SERVICE BULLETIN

NUMBER: SB 500-57-005
MODEL: ECLIPSE EA500
SUBJECT: WING TIP TANK FASTENER INSPECTION-REPAIR

**Correct Installation of Fasteners - Left Side Tank View Looking Forward and Inboard
Figure 2 (Sheet 1 of 1)**

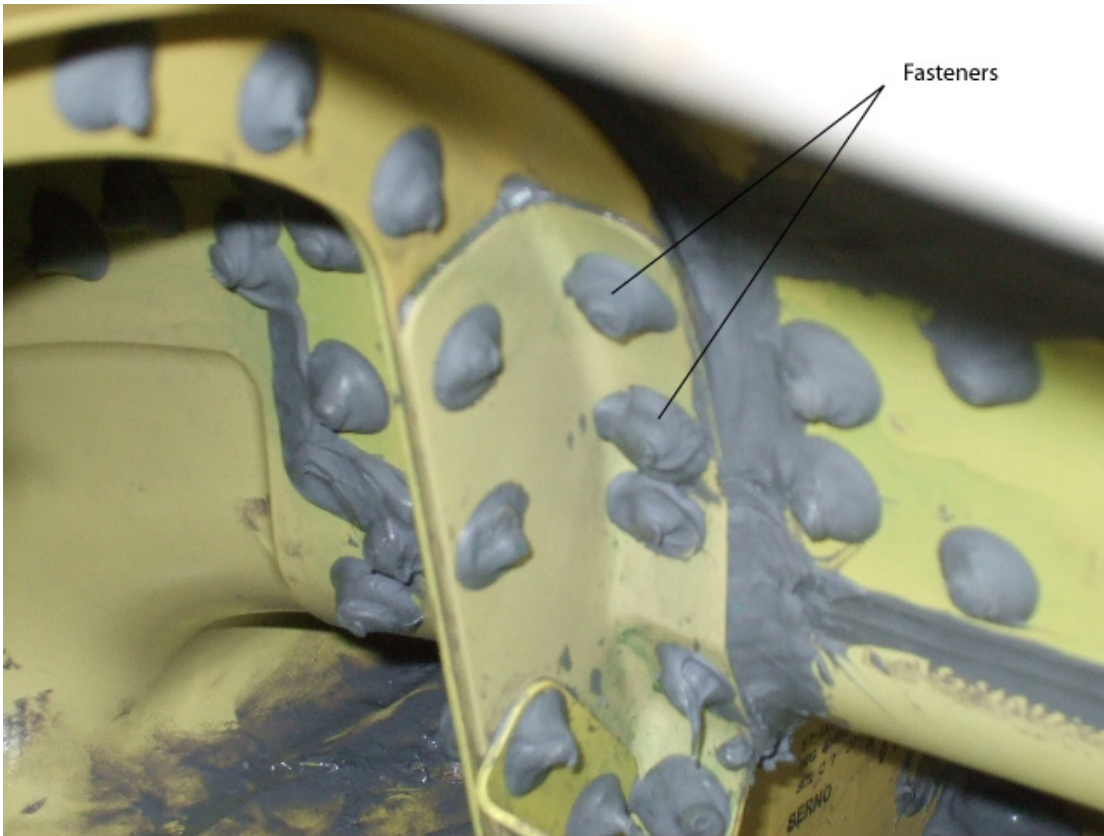
- (1) Inspect both the left and right tip tanks.
- (2) Defuel, if necessary, enough fuel to make sure that the tip tanks are empty.
- (3) Remove tip tank filler cap. Refer to AMM-28-10-10 Fuel Tank Filler Cap – Removal, Config B.
- (4) Navigating through the fuel tank filler port with a borescope, check that two fasteners are installed on the Forward Spar Former and Support as shown in Figure 2.

**Missing Fasteners - Right Side Tank, View Looking Forward and Inboard
Figure 3 (Sheet 1 of 1)**

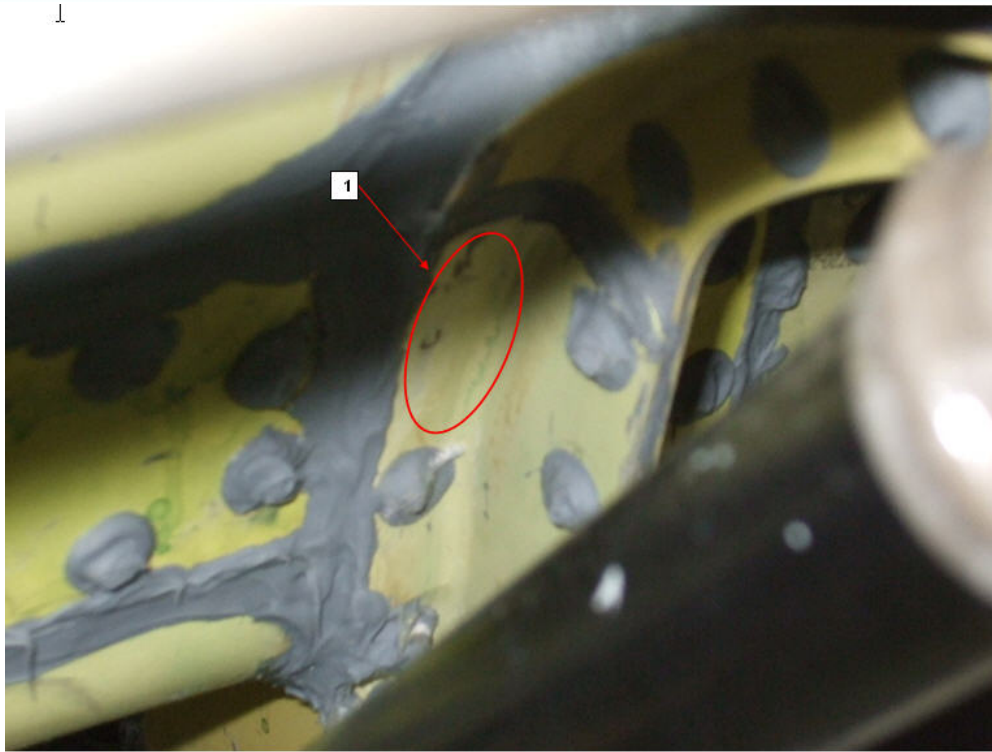
- (5) If fasteners are missing (1, Fig 3, Sheet 1), proceed to repair procedure. If not, continue to the next step.

Repair - Right Side Tank, View Looking Forward and Inboard
Figure 4 (Sheet 1 of 1)

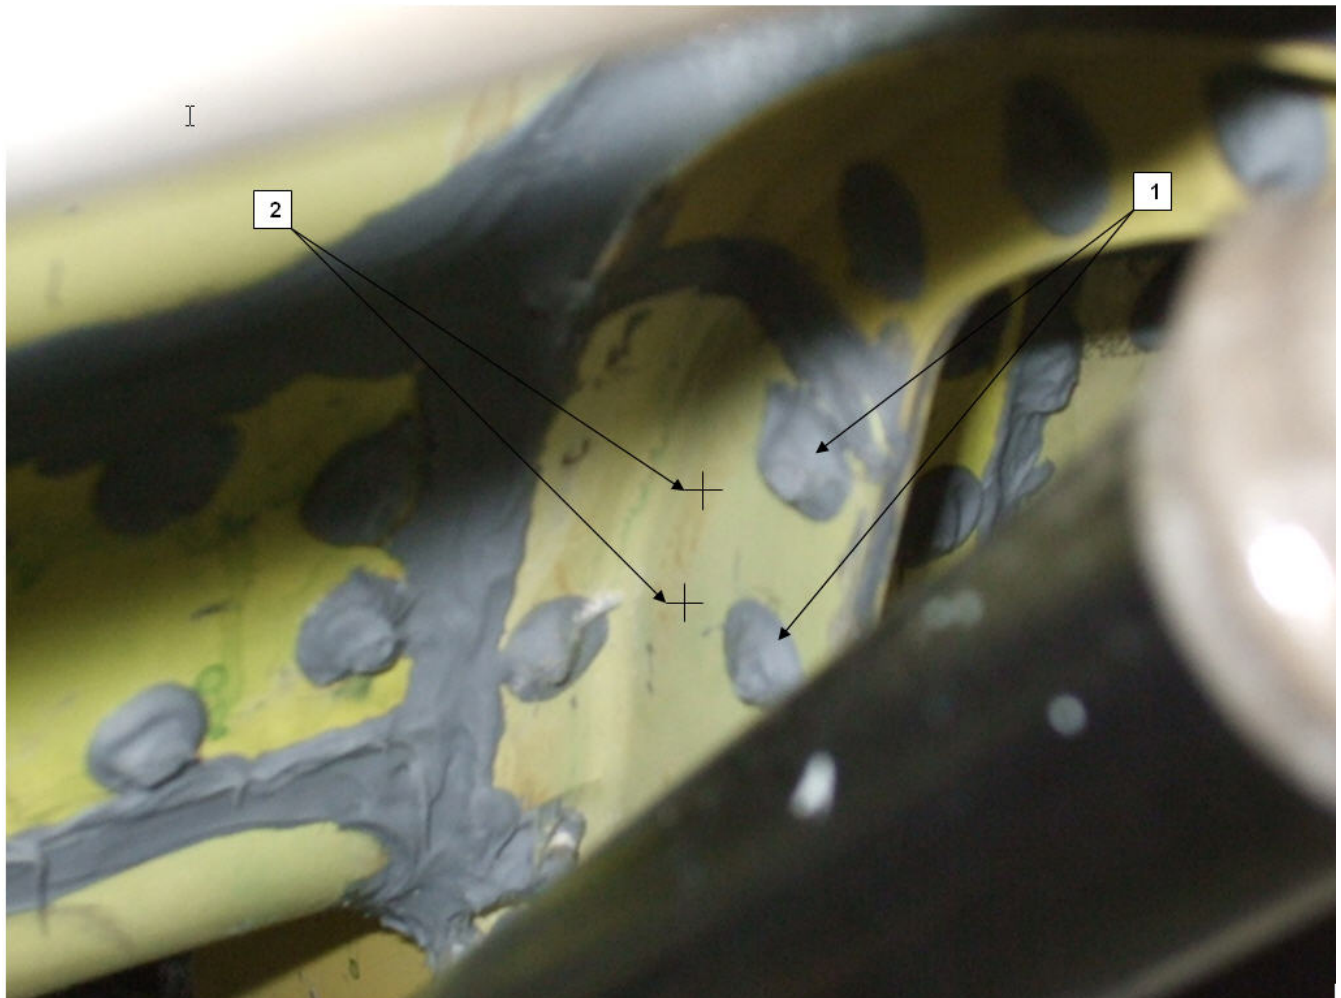
- (9) Remove two existing fasteners (1, Fig 4, Sheet 1).
 - (10) New holes are to be 0.1850" to 0.1880" diameter for interference fit installation of HL10VAP6-4 Hi-lok Fasteners.

- (1) Remove tip tank access panel 531 MB. Refer to AMM 57-10-11 Wing Access Panel - Removal, Config B.
- (2) Remove fuel filler adapter. Refer to AMM-28-10-11 Fuel Filler Adapter - Removal, Config B.
- (3) Remove tip tank fuel probe from its mounting brackets without disconnecting the wiring. Lay fuel probe to the side to allow access to repair area. Refer to AMM-28-40-10-001-801-B Fuel Gauge Probe - Removal.
- (4) Locate and drill two new holes 0.1850" to 0.1880" diameter (2, Fig 4, Sheet 1) for interference fit installation of HL10VAP6-4 Hi-lok Fasteners .

- (7) Install two HL10VAP6-4 Hi-lok fasteners wet with PPG Aerospace (PRC-DeSoto) PR-2001 Class B sealant and HL70-6 collars in newly prepared holes (2, Fig 4, Sheet 1). Use NAS1049D0332J washers as necessary to compensate for grip length. Refer to Subtask AMM-20-08-00-051-361-007 for sealant application.

- (11) Remove any chips and burrs from holes.
- (12) Clean area with Dynamold DS-108 (DS-108F) or a 50/50 volume percent blend of acetone and isopropyl alcohol.
- (13) Install two HL10VAP6-4 Hi-lok fasteners wet with PPG Aerospace (PRC-DeSoto) PR-2001 Class B sealant and HL70-6 collars in holes where fasteners were removed (1, Fig 4, Sheet 1). Use NAS1049D0332J washers as necessary to compensate for grip length. Refer to Subtask AMM-20-08-00-051-361-007 for sealant application.
